PIC32MZ Graphics (DA) Family Silicon Errata and Data Sheet Clarification

The PIC32MZ Graphics (DA) family devices that you have received conform functionally to the current Device Data Sheet (DS60001361H), except for the anomalies described in this document.

FIGURE 1: Posc CRYSTAL CIRCUIT

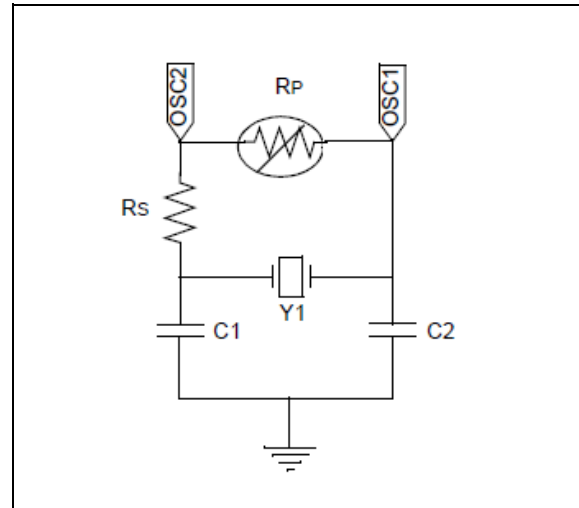
The POSC has been tested in a normal power-up sequence and supports specific crystal operation.

The Primary Oscillator (POSC) has been characterized to operate at 8 MHz and 12 MHz when the circuit shown in Figure 1 is implemented, and the operating conditions listed in Table 3 are met.

Crystal Frequency (See Note 1)	Series Resistor Rs	Posc Gain Setting POSCGAIN<1:0> (DEVCFG0<20:19>)	Posc Boost Setting POSCBOOST (DEVCFG0<21>)
8 MHz	2 kΩ	'0b00 (GAIN_0)	'0b1
12 MHz	1 kΩ	'0b00 (GAIN_0)	'0b1

Note 1: Using any other crystal frequency will require special component selection and characterization.

2: A parallel register (Rp) should not be used to increase the gain of the Posc.

FIGURE 2: EXTERNAL RESET CIRCUIT

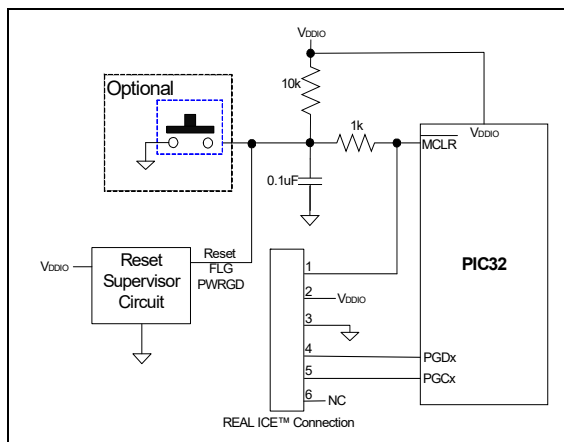
A system Reset is not generated on a BOR event ($V_{PORIO} < V_{DDIO} < V_{BORIO}$). This will stop system clocks with all the I/O pin functions frozen in the present state until either V_{DDIO} falls to V_{PORIO} or $V_{DDIO} > V_{BORIO}$.

Reset device using a $\overline{MCLR}$ pin through an external reset supervisor/monitor is shown in Figure 2. Set the SMCLR (DEVCFG2<15>) configuration bit to '0', which makes the $\overline{MCLR}$ to act as a POR Reset instead of a normal system reset.

- Minimum Reset trip voltage of the external supervisor should be $V_{BORIO} (Max) + 0.5V$.
- The external reset supervisor/LDO output going to $\overline{MCLR}$ should have an open drain output to not interfere with the MPLAB programming/debug tools.

When this work around is implemented, the minimum V_{DDIO} operating voltage of the application needs to be above the reset supervisor maximum trip voltage + 0.2V, where 0.2V compensates for variation in the external reset supervisor voltage.
